Update: SIB 61 07 24 Recall 24V-557: Replace Starter Relay

SIB 61 07 24 RECALL 24V-557 Replace Starter Relay

This Service Information Bulletin replaces SIB 00 10 21 **dated Aug 20, 2024.**

00 60 397 Converting starter motor relay

**6****► Removing semiconductor starter relay**

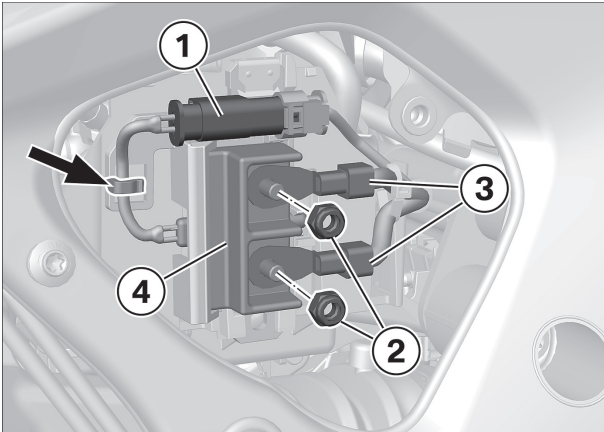
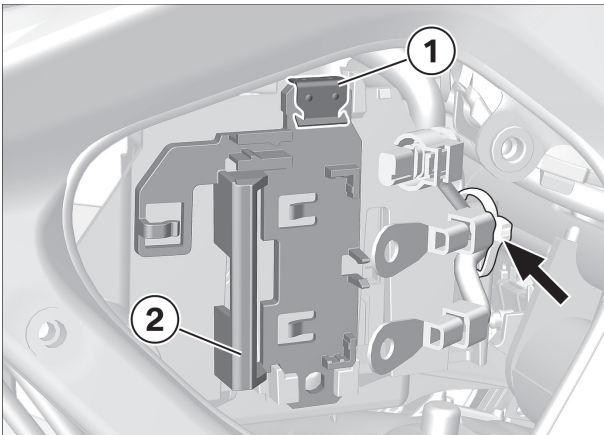
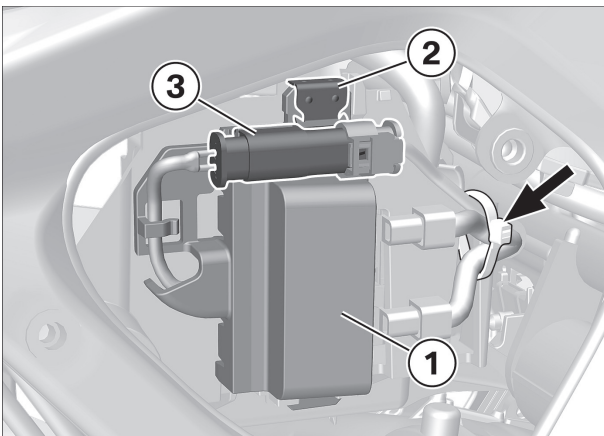
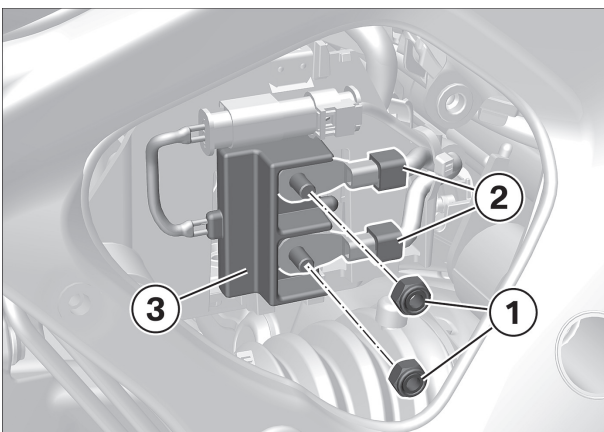
- There are two build levels of the semiconductor starter relay:
 - Starter motor relay with holder
 - Starter motor relay with cover cap
- Select the respective repair method according to the build level.

- Disconnect connector **(1)** and detach cable **(arrow)**.
- Remove nuts **(2)**.
- Loosen cable shoes **(3)**.
- Loosen starter motor relay **(4)** from holder and thread out connector **(1)**.

- Remove cable strap **(arrow)**.
- Remove clamp **(1)** and remove holder **(2)**.

- Remove cable strap **(arrow)**.
- Disconnect connector **(3)**.
- Remove clamp **(2)** and remove retaining cap **(1)**.

- Remove nuts **(1)**.
- Loosen cable shoes **(2)**.
- Remove starter motor relay **(3)**.

► **Installing electromagnetic starter relay**

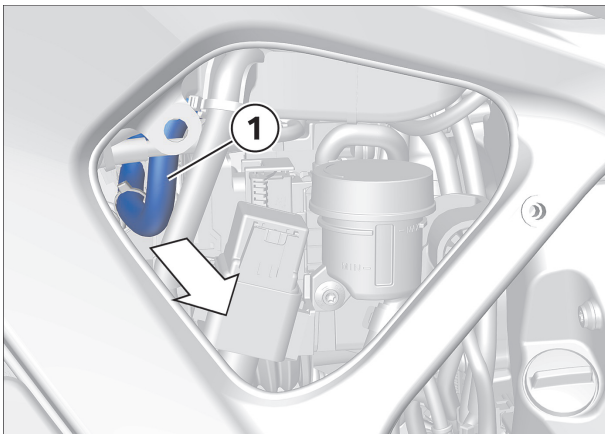
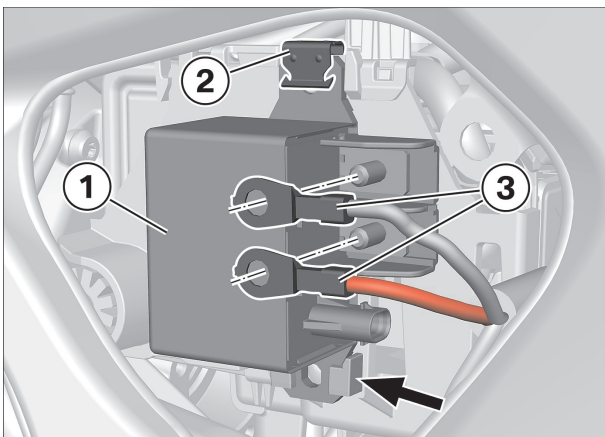
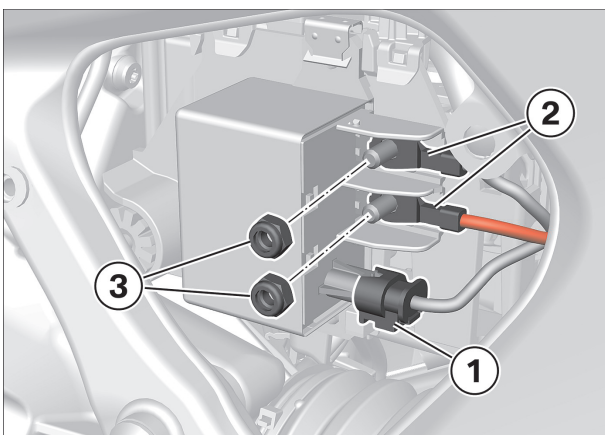
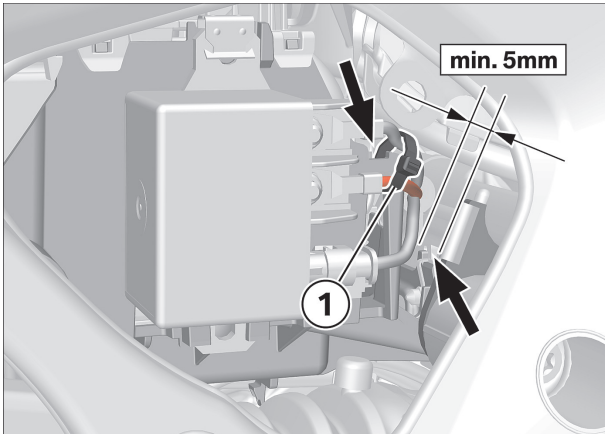
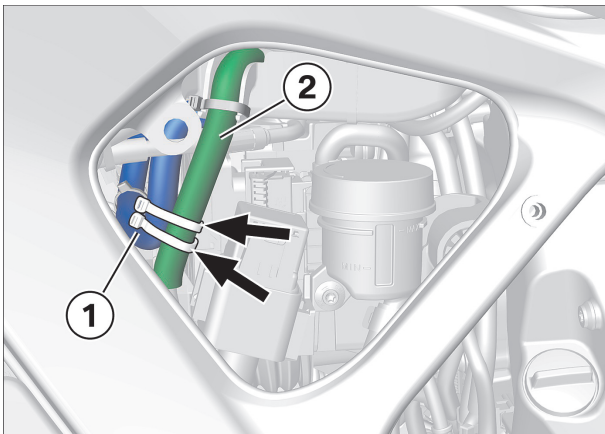
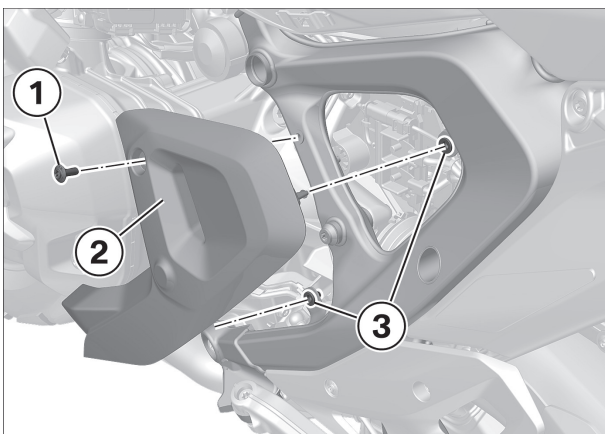
Wiring harness is damaged by chafing

Component damage, cable fire

- Ensure sufficient distance to frame and body parts.
- Route wiring harness accordingly and fasten it in place with cable straps.

- Pull the wiring harness **(1)** outwards slightly.

- Position the starter motor relay **(1)** in the bracket **(arrow)**.
- Install retaining clip **(2)**.
- Align cable shoe **(3)** on stud.

- Connect connector **(1)**.
- Secure cable shoes **(2)** with nuts **(3)**.

Tightening torques		
Wiring harness to starter relay		
M6, Renew nut	5 Nm	
Thread-locking compound (mechanical)

- Cable shoes are located at the bottom of the limit positions.
- Install cable strap **(1)** but do **not tighten** it yet.
Only secure the upper cables on the equipment holder.
- Make sure that the wiring harness is not in contact with the frame eyelet or frame plate **(arrows)**.

Minimum distance must be maintained under all circumstances, line continuous current!

- Tighten cable straps **(1)**.
- **If the minimum distance is not reached:** Create TSARA case and follow the instructions.

- Secure wiring harness **(1)** with **two** cable straps **(arrows)** on wiring harness **(2)**.
Install the lower cable strap as close as possible to the cable bend to prevent the cable from springing back.
